RESOLUTION NO. 13-14

RESOLUTION OF THE TOWN OF ST. LEO TOWN COMMISSION  
APPROVING SAINT LEO UNIVERSITY INC. PLANT OPERATIONS PROJECT SITE  
PLAN (SPR#13-B) WITH CONDITIONS.

**SITE/LANDSCAPE PLAN REVIEW (SPR)  
STAFF REPORT  
SPR#13-B: Saint Leo University Plant Operations Project  
Town Commission meeting August 12, 2013**

East Elevation  
1/8" = 1'-0"

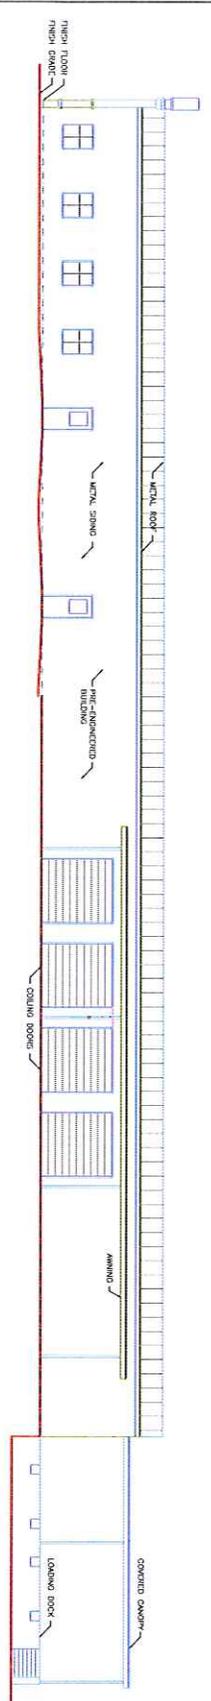
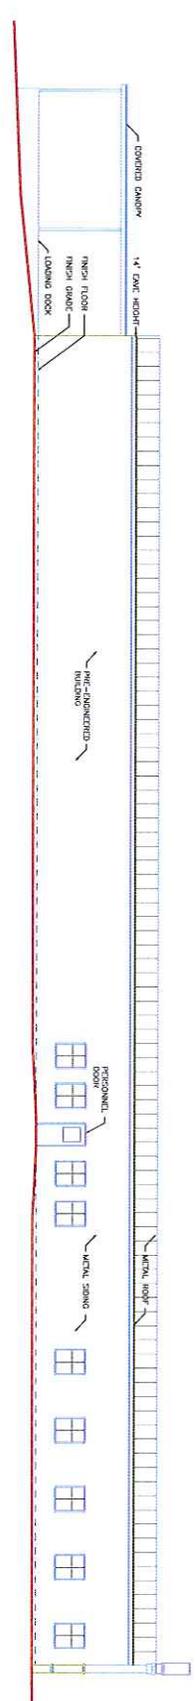
The east and west elevations are visible from S.R. 52 and are long linear walls (185’+/- feet) with no wall plane breaks or vertical elements to provide visual relief from these long linear facades. Although there is some relief from the landscape buffer along the west property boundary, additional design elements are necessary on both facades. This design issue can be addressed in several ways:

1. Incorporate vertical elements (such as columns) along the facades.
2. Incorporate parapet roof elements in combination with canopy trees and/or Palm clusters along the facades.
3. Any combination of the above.
